# Three lines of thought about Lower Shaker Lake dam

- 1) Downsizing the NEORSD design would meet local needs
- 2) Understanding the dam failure hazards and working towards a non-Class-I project
- 3) The lake and the 15 minute city

Ben Monreal  
Shaker Heights  
Professor of Physics, CWRU

### Scenario 3: 17"--26" Hurricane Helene-like megaflood

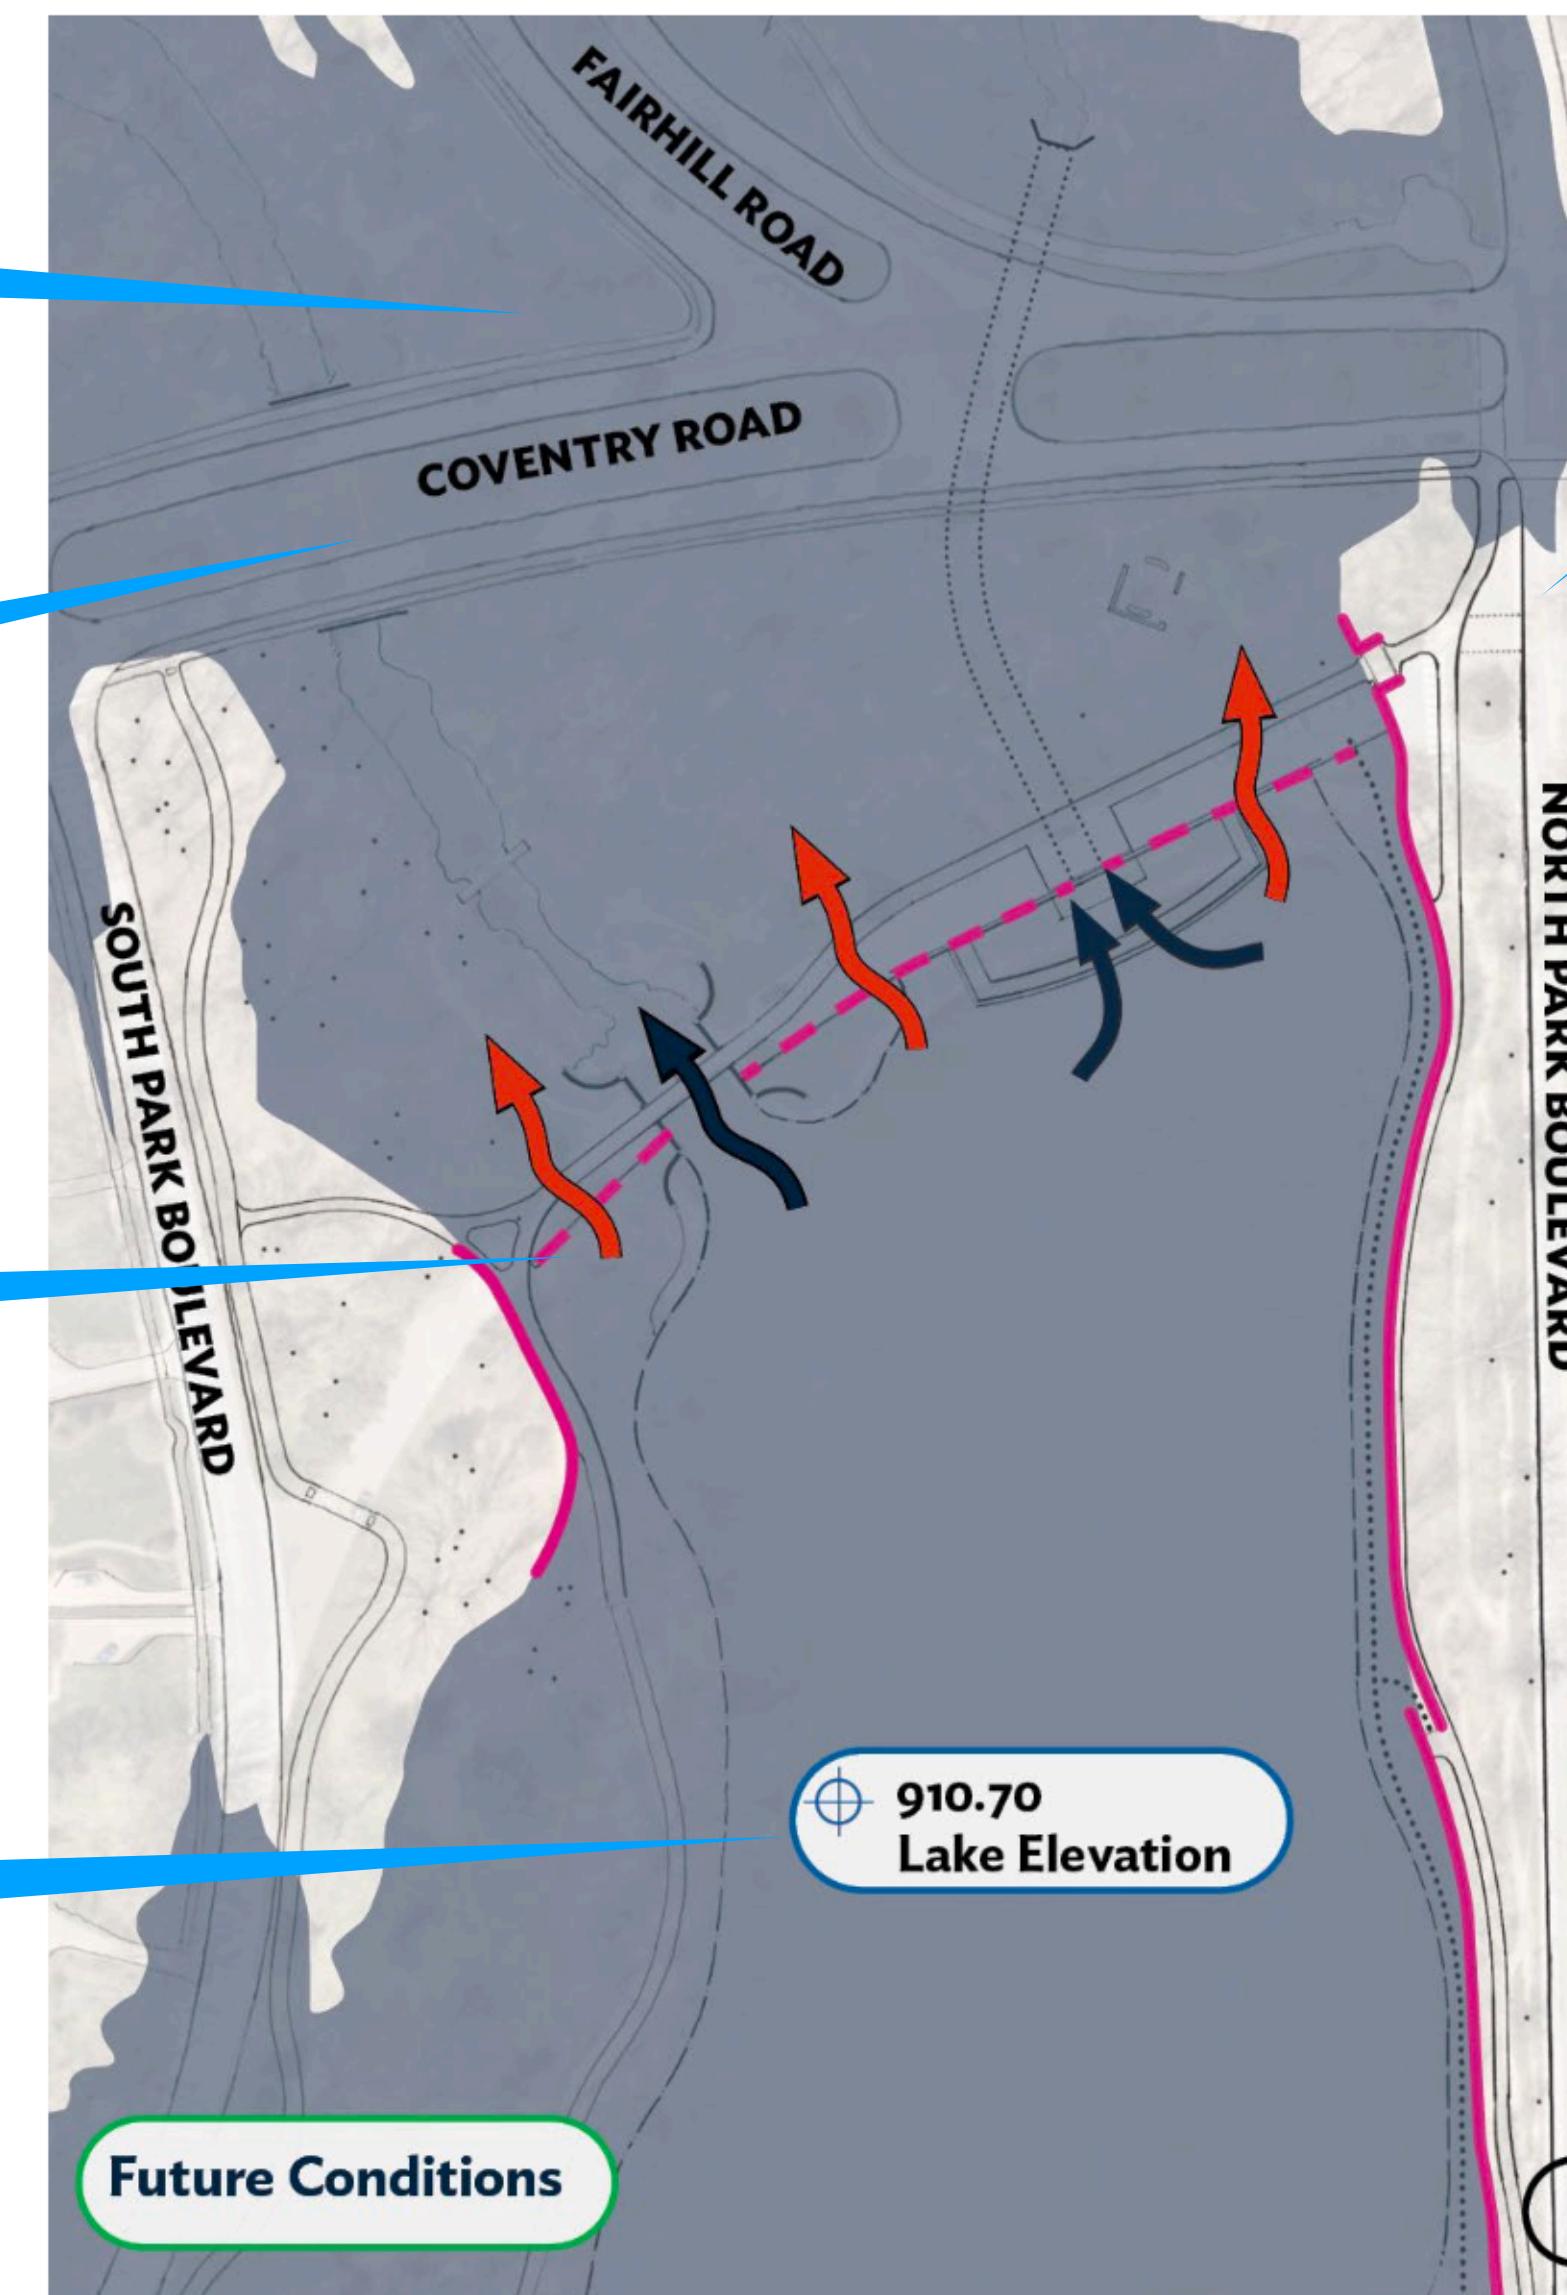
NEORSD's expensive floodwall protects ... the lakeside footpath?

Floodplains and upper canyons backed up, probably as far as N Moreland

Culverts under Coventry are backed up, most flow is over road

Spillways are backed up, most flow is over dam

Water still backs up in lake up to 910.7'; floods basements along South Park

(Won't it just flood with surface runoff from the north?)

My opinion: An 8000 acre-foot storm like this will fill this floodplain in roughly this pattern whether there is a dam there or not.
